# ACCESSIBILITY ASSESSMENT

*July 18, 2021*

## **ADA TITLE II ASSESSMENT**

Brinkley Hills  
6021 Thunder Hill Court  
Fort Washington, Maryland 20744

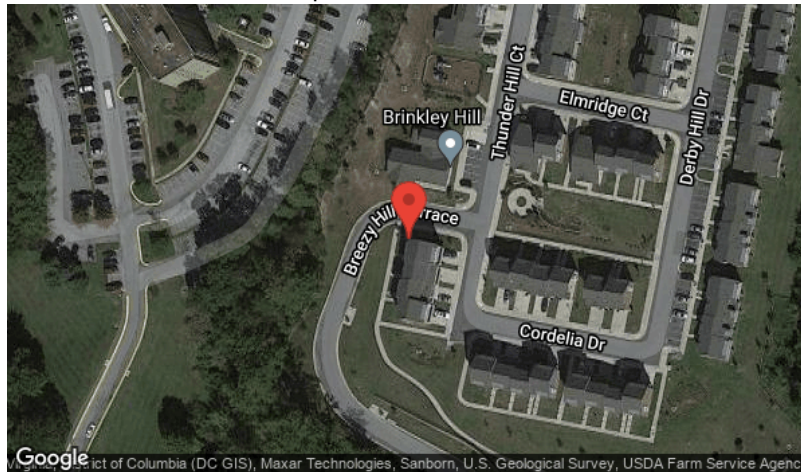
Location Description	Ramp R2
Observed	May 18, 2021 by Ouraccessibleworld@gmail.com

The accessible route has a cross slope of up to 3.6% and a running slope of up to 11.4% for a distance of approximately 30 linear feet x 5'. Based on an average of the slopes a ramp with a rise of 34" is needed. The ramp will need a top and bottom landing and 1 intermediate landing.

Remove the existing ramp and provide a compliant ramp. Ramp runs shall have a running slope not steeper than 1:12 (8.33%). [EXCEPTION: In existing sites, buildings, and facilities built before January 1992, ramps shall be permitted to have running slopes steeper than 1:12 where such slopes are necessary due to space limitations. Where slopes are steeper than 1:10 but not steeper than 1:8, the rise shall be 3" maximum. Where slopes are steeper than 1:12 but not steeper than 1:10, the rise shall be 6" maximum.] Ramp runs shall have cross slopes not greater than 1:50 (2%). [EXCEPTION: Cross slopes not greater than 1:48 (2.08%) are permitted.] Either regrade to a maximum running slope of 1:20 (5%) for the walking surface, or provide a compliant ramp. The cost estimate for this barrier removal is based on providing a compliant ramp. The quantity and order of magnitude cost estimate provided for this barrier are limited to the extent of the area identified as non-compliant. Additional costs that may be associated with removal of the barrier are not included.

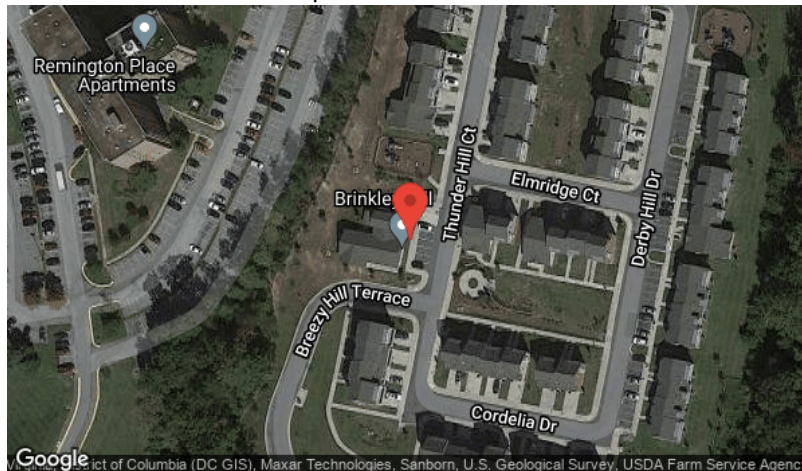
<b>Assembly</b>	Exterior Access Route
<b>Type</b>	Ramp
<b>ADA Standard</b>	405.8 and 505
<b>Barrier Detail</b>	The ramp run has a rise greater than 6"; however, handrails are not provided.
<b>Location Description</b>	Ramp R3
<b>Observed</b>	May 18, 2021 by Ouraccessibleworld@gmail.com

The accessible route has a running slope from 6.9% to 8.9% for a distance of approximately 25 linear feet x 5'. Based on the average of the slopes a ramp with a rise of 24" is needed. the ramp will need handrails.

Provide compliant handrails or provide ramp runs with maximum 6" rise. Handrails are required on ramp runs which rise more than 6". Replace with continuous handrails at a consistent height above the ramp on both sides of the ramp. Inside handrails on switchback or dogleg stairs and ramps shall be continuous between runs. Top of gripping surfaces of handrails shall be 34" minimum and 38" maximum vertically above ramp surfaces. Handrails shall be at a consistent height above ramp surfaces. Clearance between handrail gripping surfaces and adjacent surfaces shall be 1-1/2" minimum. Handrail gripping surfaces shall be continuous along their length and shall not be obstructed along their tops or sides. The bottoms of handrail gripping surfaces shall not be obstructed for more than 20% of their length. Where provided, horizontal projections shall occur 1-1/2" minimum below the bottom of the handrail gripping surface. [EXCEPTIONS: 1. Where handrails are provided along walking surfaces with slopes not steeper than 1:20, the bottoms of handrail gripping surfaces shall be permitted to be obstructed along their entire length where they are integral to crash rails or bumper guards. 2. The distance between horizontal projections and the bottom of the gripping surface shall be permitted to be reduced by 1/8" for each 1/2" of additional handrail perimeter dimension that exceeds 4".] Handrail gripping surfaces with a circular cross section shall have an outside diameter of 1-1/4" minimum and 2" maximum. Handrail gripping surfaces with a non-circular cross section shall have a perimeter dimension of 4" minimum and 6-1/4" maximum, and a cross-section dimension of 2-1/4" maximum. Handrail gripping surfaces and any surfaces adjacent to them shall be free of sharp or abrasive elements and shall have rounded edges. Handrails shall not rotate within their fittings. Handrail gripping surfaces shall extend beyond and in the same direction of ramp runs. [EXCEPTIONS: 1. Extensions shall not be required for continuous handrails at the inside turn of switchback or dogleg ramps AND 3. In alterations, full extensions of handrails shall not be required where such extensions would be hazardous due to plan configuration.] Ramp handrails shall extend horizontally above the landing for 12" minimum beyond the top and bottom of ramp runs. Extensions shall return to a wall, guard, or the landing surface, or shall be continuous to the handrail of an adjacent ramp run.

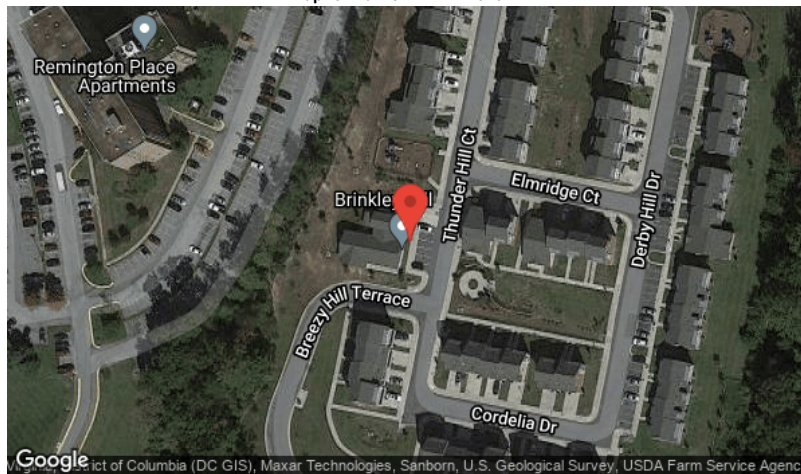
Location Description	Ramp R3
Observed	May 18, 2021 by Ouraccessibleworld@gmail.com

The accessible route has a running slope from 6.9% to 8.9% for a distance of approximately 25 linear feet x 5'. Based on an average of the slopes a ramp with a rise of 24" is needed. The ramp will need a top and bottom landing.

Remove the existing ramp and provide a compliant ramp. Ramp runs shall have a running slope not steeper than 1:12 (8.33%). [EXCEPTION: In existing sites, buildings, and facilities built before January 1992, ramps shall be permitted to have running slopes steeper than 1:12 where such slopes are necessary due to space limitations. Where slopes are steeper than 1:10 but not steeper than 1:8, the rise shall be 3" maximum. Where slopes are steeper than 1:12 but not steeper than 1:10, the rise shall be 6" maximum.] Ramp runs shall have cross slopes not greater than 1:50 (2%). [EXCEPTION: Cross slopes not greater than 1:48 (2.08%) are permitted.] Either regrade to a maximum running slope of 1:20 (5%) for the walking surface, or provide a compliant ramp. The cost estimate for this barrier removal is based on providing a compliant ramp. The quantity and order of magnitude cost estimate provided for this barrier are limited to the extent of the area identified as non-compliant. Additional costs that may be associated with removal of the barrier are not included.

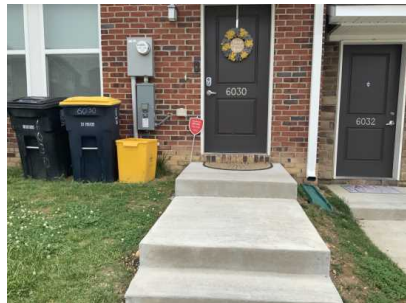
<b>Assembly</b>	Entrance to Building
<b>Type</b>	Building Entrance-Door
<b>ADA Standard</b>	UFAS 4.1 4.3.2; 4.14
<b>Barrier Detail</b>	An accessible entrance is not provided to the facility.
<b>Location Description</b>	Entrances - Unit 6026, 6028 and 6030
<b>Observed</b>	May 18, 2021 by Ouraccessibleworld@gmail.com

The units have stairs at the main entrance. A ramp with a rise of 20" with handrails is required at each entry.

Provide at least one accessible entrance on an accessible route. Entrances shall be provided as necessary to achieve access to and egress from buildings and facilities. [EXCEPTION: In projects consisting of one-to-four family dwellings where accessible entrances would be extraordinarily costly due to site conditions or local code restrictions, accessible entrances are required only to those buildings containing accessible dwelling units.] Entrances required to be accessible shall be part of an accessible route. Such entrances shall be connected by an accessible route to public transportation stops, to accessible parking and passenger loading zones, and to public streets or sidewalks if available. They shall also be connected by an accessible route to all accessible spaces or elements within the building or facility. A service entrance shall not be the sole accessible entrance, unless it is the only entrance to a building or facility (for example, in a factory or garage).

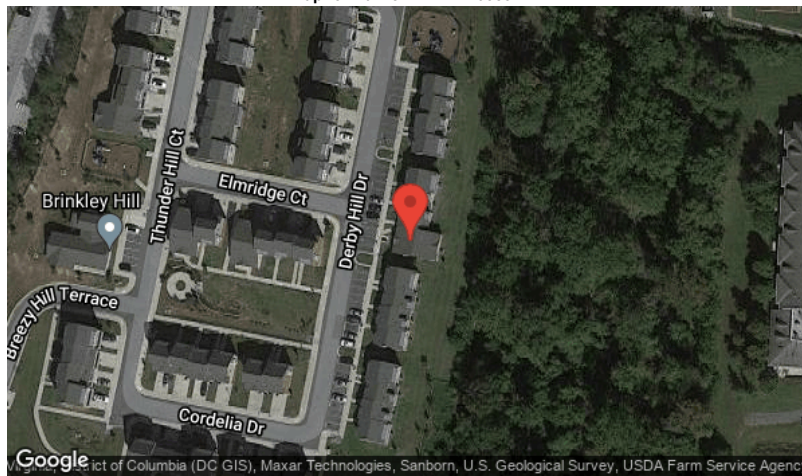
<b>Assembly</b>	Exterior Access Route
<b>Type</b>	Exterior Accessible Route
<b>ADA Standard</b>	305, 309
<b>Barrier Detail</b>	Clear ground space is not provided at the operable part.
<b>Location Description</b>	Mailboxes for Units
<b>Observed</b>	May 19, 2021 by Ouraccessibleworld@gmail.com
<b>Site Conditions</b>	The clear space at the mailboxes has a slope of up to 4.4%.

Provide clear ground space at the operable part. The clear ground space shall be 30" minimum by 48" minimum, with a maximum slope of 2.08% in all directions. Clear ground space shall be positioned for either a forward or parallel approach to the operable part. The clear ground space shall be permitted to include knee and toe clearance. The clear ground space shall adjoin an accessible route or another clear ground space. Where a clear ground space is located in an alcove or otherwise confined on 3 or more sides, additional maneuvering clearance shall be provided. Alcoves shall be 36" wide minimum where the depth exceeds 24" for a forward approach. Alcoves shall be 60" wide minimum where the depth exceeds 15" for a parallel approach.

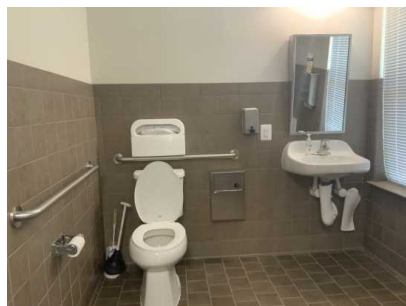
<b>Location Description</b>	Laundry Restroom
<b>Observed</b>	May 19, 2021 by Ouraccessibleworld@gmail.com

The clear space a the water closet is 57-1/2" measured perpendicular from the side wall to the edge of the lavatory.

Redesign to provide compliant water closet clearance. Clearance around a water closet shall be 60" minimum measured perpendicular from the side wall and 56" minimum measured perpendicular from the rear wall. The water closet shall be positioned with a wall or partition to the rear and to one side. The centerline of the water closet shall be 16" minimum to 18" maximum from the side wall or partition, except that the water closet shall be 17" minimum and 19" maximum from the side wall or partition in the ambulatory accessible toilet compartment. Water closets shall be arranged for a left-hand or right-hand approach. The required clearance around the water closet shall be permitted to overlap the water closet, associated grab bars, dispensers, sanitary napkin disposal units, coat hooks, shelves, accessible routes, clear floor space and clearances required at other fixtures, and the turning space. No other fixtures or obstructions, such as lavatories, shall be located within the required water closet clearance. [ADVISORY: It is advisable, but not required, to use the specifications for children where children are the primary users of the restroom. Guidance in applying the specifications for children according to the age group served reflects the differences in the size, stature, and reach ranges of children ages 3 to 12. The specifications chosen should correspond to the age of the primary user group. The specifications of one age group should be applied consistently in the installation of a water closet and related elements. Water Closet Centerline: Ages 3 and 4- 12"; Ages 5 through 8- 12" to 15"; Ages 9 through 12- 15" to 18". Toilet Seat Height: Ages 3 and 4- 11" to 12"; Ages 5 through 8- 12" to 15"; Ages 9 through 12- 15" to 17". Grab Bar Height: Ages 3 and 4- 18" to 20"; Ages 5 through 8- 20" to 25"; Ages 9 through 12- 25" to 27"; Dispenser Height: Ages 3 and 4- 14"; Ages 5 through 8- 14" to 17"; Ages 9 through 12- 17" to 19"].

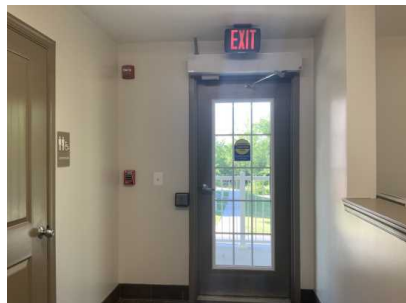
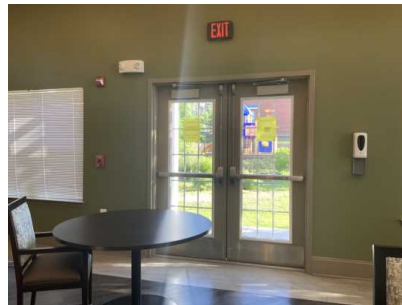
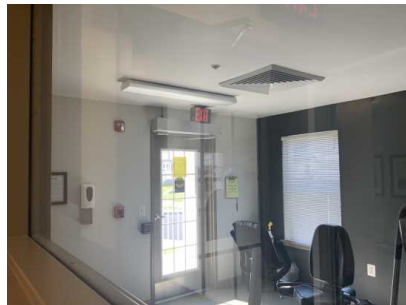
<b>Assembly</b>	Interior Access Route
<b>Type</b>	Signage
<b>ADA Standard</b>	216.4, 703.1, 703.4
<b>Barrier Detail</b>	Means of egress signage is not provided.
<b>Location Description</b>	Office
<b>Observed</b>	May 19, 2021 by Ouraccessibleworld@gmail.com

Means of egress signage with compliant tactile characters is not provided at the exits.

Provide compliant means of egress signage at each exit passageway, exit discharge, and exit stairway. Signs at designated egress passageways, stairways, exit doors and areas of refuge shall include tactile signage. Signs shall be installed alongside the door at the latch side. [EXCEPTION: Signs with tactile characters shall be permitted on the push side of doors with closers and without hold-open devices.] Where a tactile sign is provided at double doors with one active leaf, the sign shall be located on the inactive leaf. Where a tactile sign is provided at double doors with two active leaves, the sign shall be located to the right of the right hand door. Where there is no wall space at the latch side of a single door or at the right side of double doors, sign shall be located on the nearest adjacent wall. Where both visual and tactile characters are required, either one sign with both visual and tactile characters, or two separate signs, one with visual, and one with tactile characters, shall be provided. Signs containing tactile characters shall be located so that clear floor space of 18" minimum by 18" minimum, centered on the tactile characters, is provided beyond the arc of any door swing between the closed position and 45 degrees open. Raised characters shall be complaint and shall be duplicated in Braille. Raised characters shall be as follows- Depth: Raised characters shall be 1/32" minimum above their background. Case: Characters shall be uppercase. Style: Characters shall be sans serif. Characters shall not be italic, oblique, script, highly decorative, or of other unusual forms. Character Proportions: Characters shall be selected from fonts where the width of the uppercase letter "O" is 55% minimum and 110% maximum of the height of the uppercase letter "I". Character Height: Character height measured vertically from the baseline of the character shall be 5/8" minimum and 2" maximum based on the height of the uppercase letter "I". [EXCEPTION: Where separate raised and visual characters with the same information are provided, raised character height shall be permitted to be 1/2" minimum.]

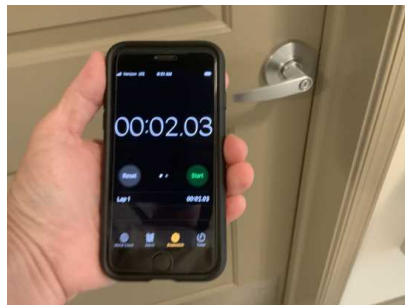
For a front approach on the push side the latch side clearance is 7". The door has a latch and closure.

Redesign to provide the required maneuvering clearance at the push side of the door. The required depth of the maneuvering clearance is 48" minimum. The required side clearance is 12" minimum on the latch side of the door. Maneuvering clearance shall extend the full width of the doorway and the required latch side clearance. Floor or ground space within the required maneuvering clearance shall be maximum 1:48 (2.08%) slope. Changes in level are not permitted.
